1992 - 1993 Corvette: Service Bulletin: Cracks/Damage to Cowl Surface

Subject: CRACKS OR DAMAGE TO COWL SURFACE

Source: Chevrolet Service Bulletin

Bulletin Number: 93-134-10

FIGURE 1

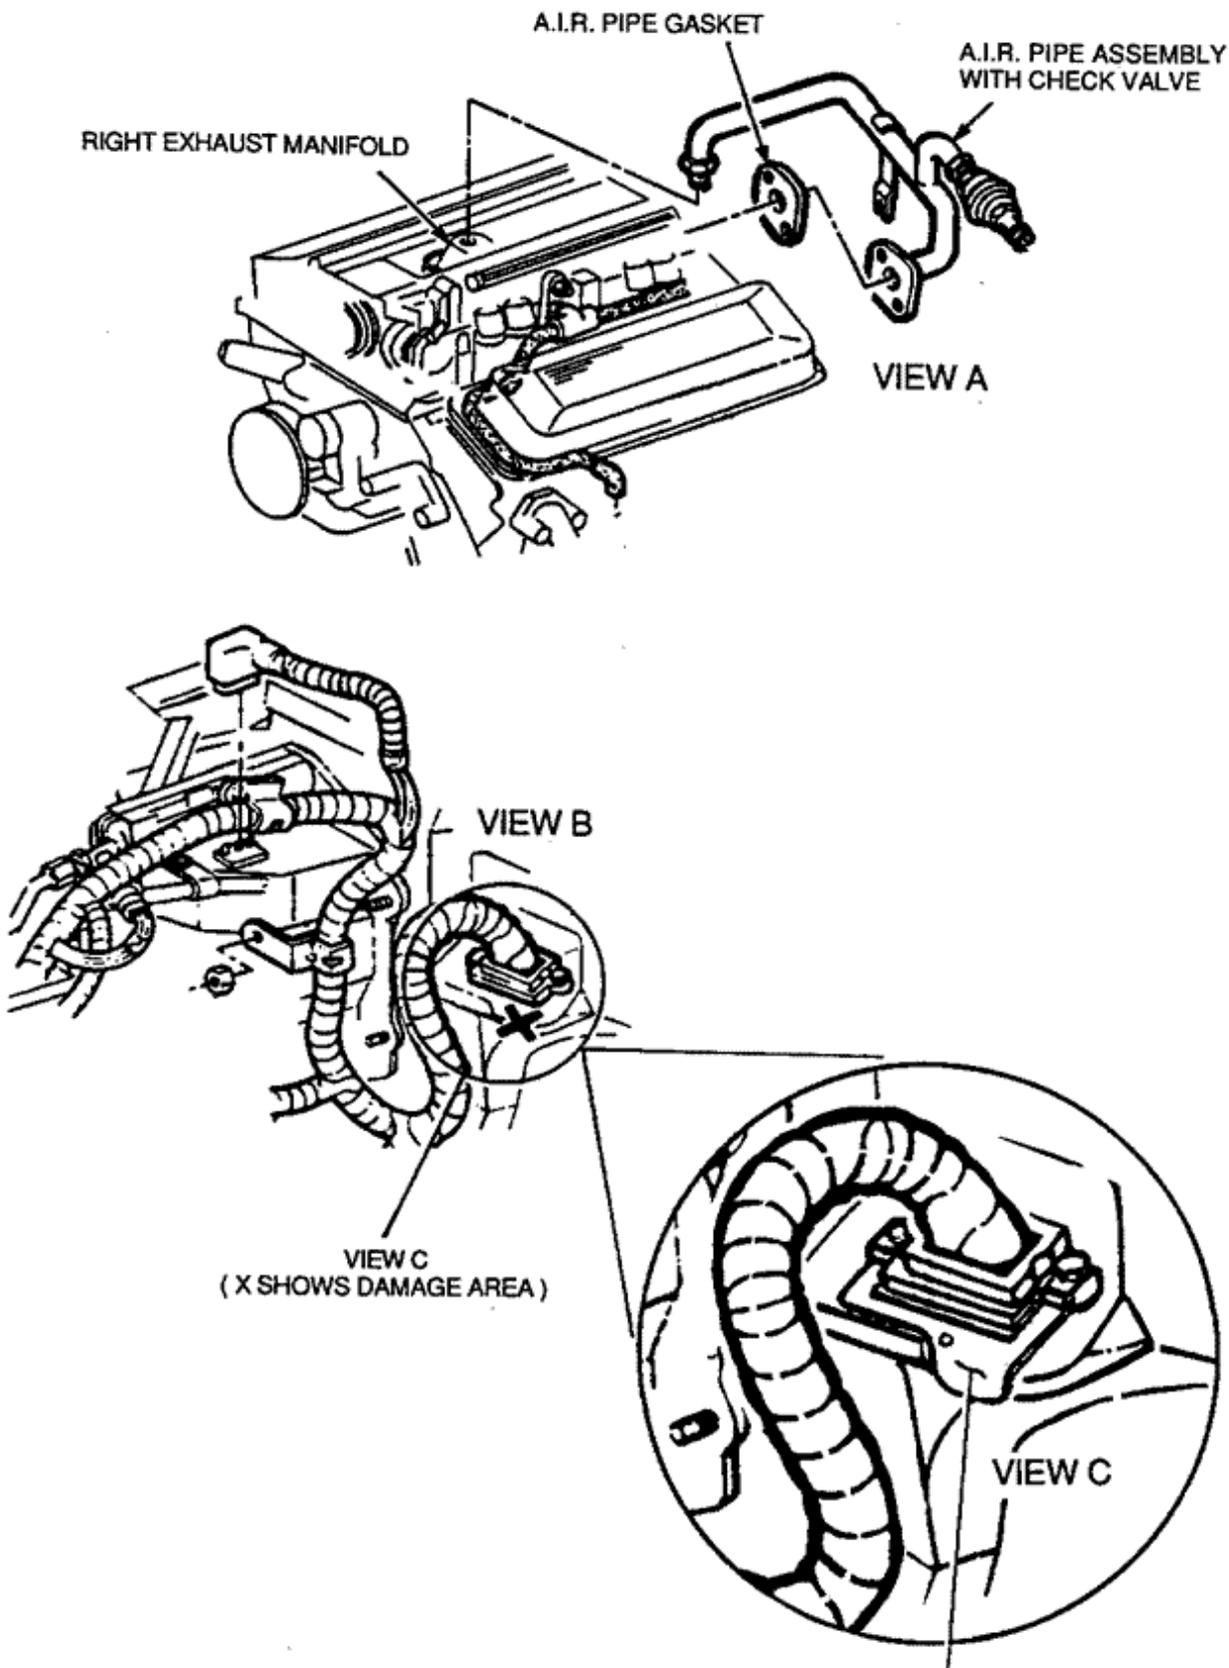
Some 1992-93 Y-cars with LT1 engines may have cracks or damage to the cowl surface:

- Behind the right cylinder head, - Below the wiring harness connector.

Rear of engine may contact the cowl surface when removing transmission or engine from vehicle.

4. Remove right side A.I.R. pipe from engine (See View A);
 - a. Remove nut at exhaust manifold, use 22 mm "crow foot" wrench.
 - b. Loosen bolt on rear of head, using long 9/16" open end wrench.

- c. Remove bolts on rear of intake manifold, use 10 mm 1/4" drive socket and flex extension.
 - d. Remove hose and plastic clamp from check valve.
5. Clean damaged area (See View B) with a wax and grease remover and use V.O.C. approved materials where required.

6. Apply enough seam sealing material to fill or cover the damaged area. Paddle material into place, if required.
7. Loosen the harness connector attaching bolts, position GM P/N 10231336 - Spacer, over the damaged area and under the attaching bolt heads and tighten the attaching bolts. The spacer has slots to aid in installation (See View C).
